Perry Nuclear Power Plant
Docket No. 50-440
Response to Request for Additional Information Related to a License Amendment
Requesting a Power Uprate (TAC No. MA6459)

Perry Nuclear Power Plant Responses to an NRC Request For Additional Information (RAI) Forwarded by Electrical Section of the Electrical and Instrumentation and Controls Systems Branch

Perry Nuclear Power Plant Responses to an NRC Request For Additional Information (RAI) Forwarded by Reactor Systems Branch

Perry 105% Power Uprate Two Loop Operation

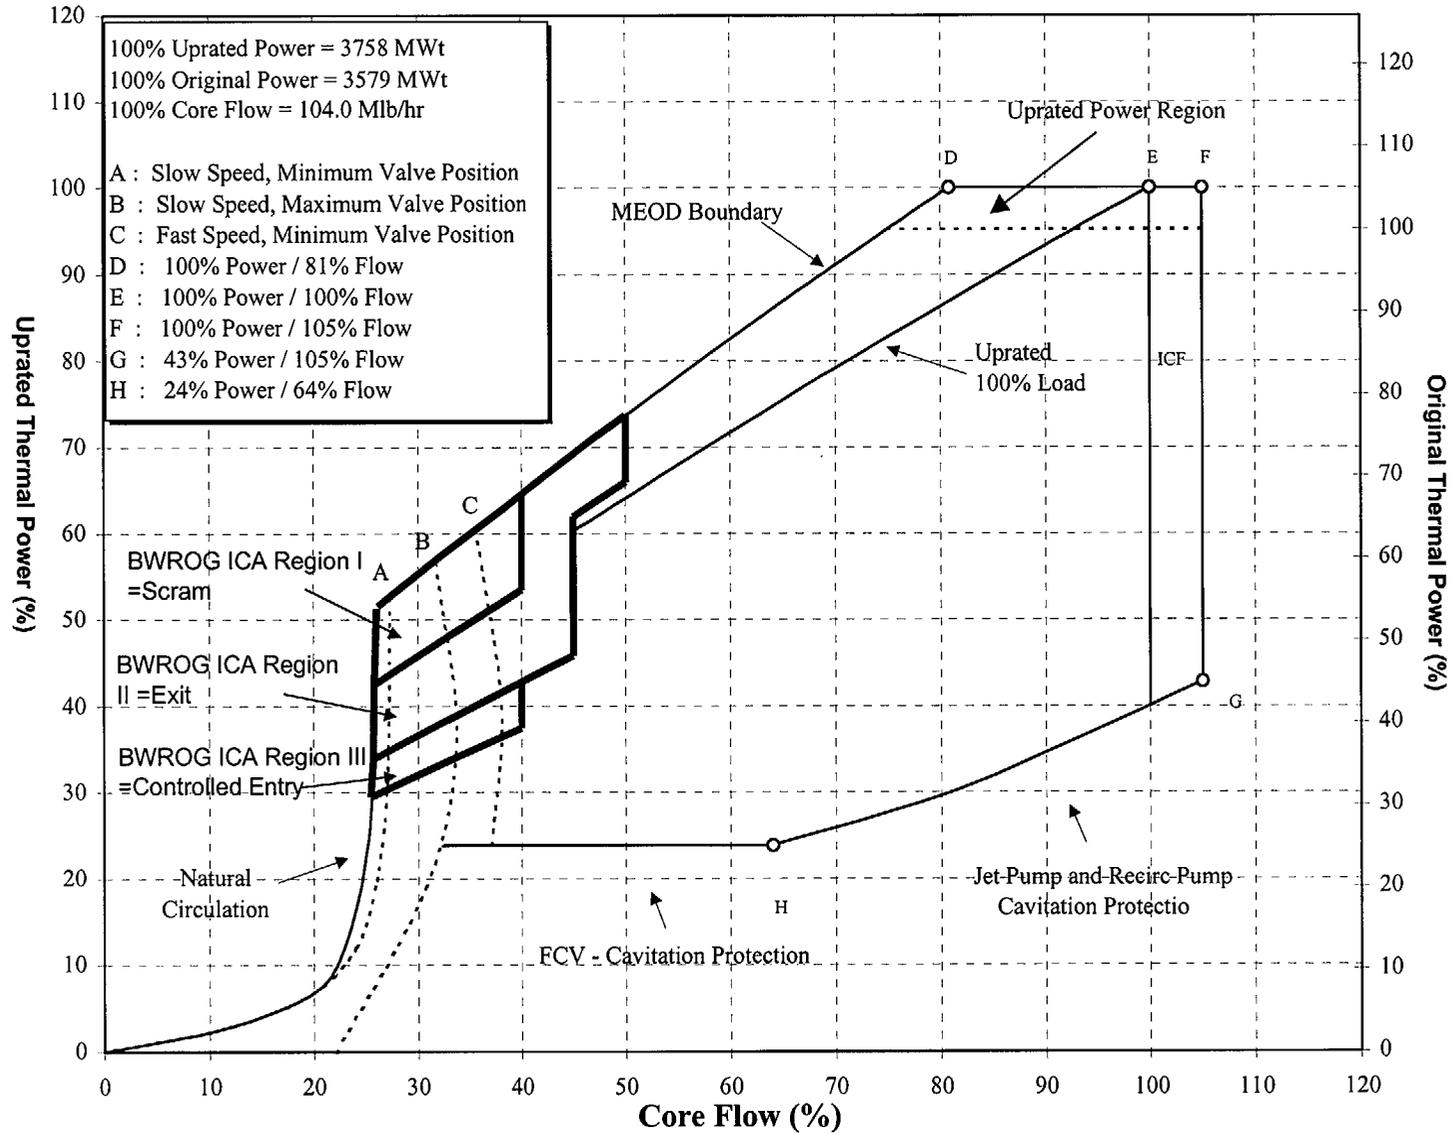
2. Explain how the maximum extended operating domain and 100-percent rod lines were determined on the proposed power-to-flow map. A figure giving the power-to-flow map with both the current and proposed power scales would be helpful for comparison.

3. Provide power-to-flow maps showing the current stability control regions and the regions under power uprate conditions. Explain any differences with the interim corrective actions defined in GE SIL 380 and discussed NRC Bulletin 88-07 Supplement 1.

The power uprate Maximum Extended Operating Domain (MEOD) line is just the pre-uprate MEOD line extended to 105% power and rescaled. The power uprate values (MWt vs. %Core Flow) below the original 100% MWt do not change. The pre-uprate 100% rod-line is the current 105% rod-line extended to 105% power and rescaled.

Figure 2-1, Perry 105% Power Uprate Two Loop Operation (TLO) Reactor Operating Domain from NEDE-32907P, "Safety Analysis Report for Perry 5% Thermal Power Uprate," (Attachment 1 of the power uprate license amendment request) is included (see page 8 of this RAI response). This Figure has a second Y-axis added to the left hand side in addition to the original (current) thermal power % on the same map.

Figure 2-1, Perry 105% Power Uprate TLO Reactor Operating Domain from NEDE-32907P (Attachment 1 of the power uprate license amendment request) is attached (see Page 8 of this RAI Response) with the Boiling Water Reactor Owners Group (BWROG) Interim Corrective Actions (ICA) regions illustrated. The Perry Plant modified operating procedures and operator training are consistent with, or more conservative than the BWROG guidelines as detailed in the response to Generic Letter 94-02, "Long-Term Solutions And Upgrade Of Interim Operating Recommendations For Thermal- Hydraulic Instabilities In Boiling Water Reactors", reference letter PY-CEI/NRR-1855L, dated September 4, 1994.

The regions have been rescaled to maintain the same absolute power and flow on the region boundaries as would exist for the revised ICAs prior to power uprate. In units of MWt, there is no change to the regions for power uprate conditions.
